MONTGOMERY COUNTY HISTORIC PRESERVATION COMMISSION STAFF REPORT

Address: 11 Columbia Avenue, Takoma Park Meeting Date: 10/9/2024

Proposal: Construction of Screened-In Porch

EXISTING & PROPOSED REAR ELEVATIONS

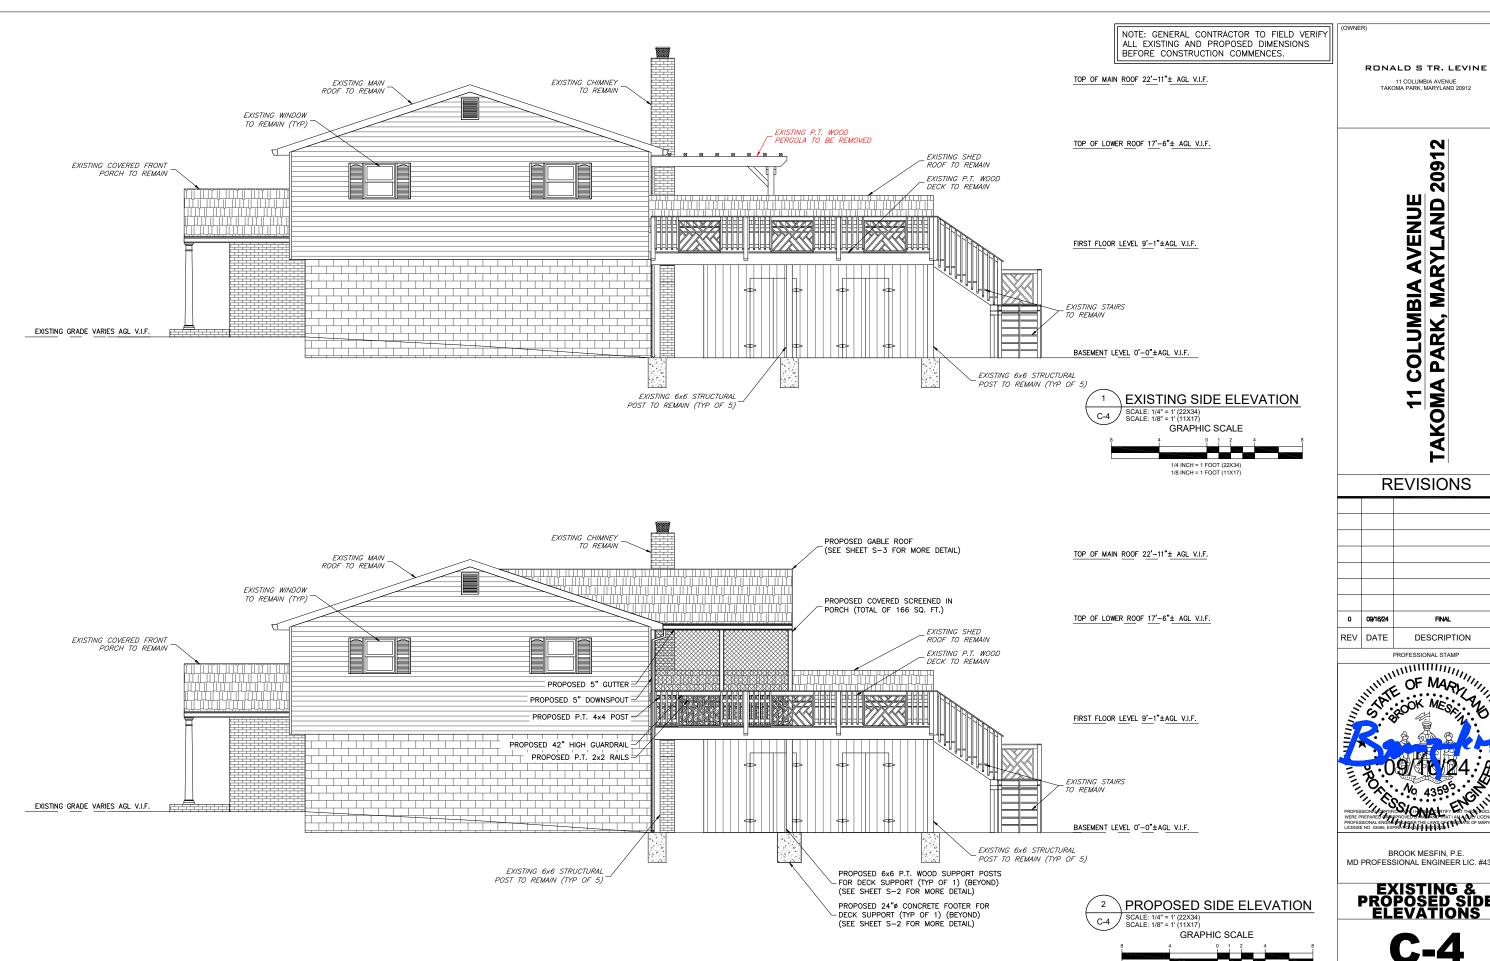
The subject property is a two-story, side-gable house with a brick first floor and aluminum siding covering the second floor. At the rear of the house, there is a wood deck with a pergola that creates a carport below. The applicant proposes to remove the pergola and to enclose a portion of the deck to create a screened-in porch. Minor modifications are proposed to the existing deck structure, but those changes will not be visible from the right-of-way.

Additionally, the applicant proposes to remove the existing rear glass door and replace it with a pair of multilight French Doors. All of the changes are at the rear and will not be at all visible from the public right-of-way.

At the rear of the house, there is a single swing glass door with a stationary panel. The applicant proposes to replace this door with a pair of French doors with a matching 3×5 light pattern. Material specifications for the proposed French doors were not included in the application materials. The size of the opening will not change. Staff finds removing and replacing the door will not impact any historic fabric, and as this is on the rear, will result in not visual change to the resource. Staff recommends the HPC approve the door replacement and add a condition that the applicant provide detailed door specifications to Staff for review and approval before approval documents can be released. With the recommended condition, Staff finds the door replacement is appropriate under the *Design Guidelines*; 24A-8(b)(2) and (d); and Standards 2, 9, and 10.

1. Detailed door specifications must be submitted to Staff for review and approval before the final approval documents can be released;
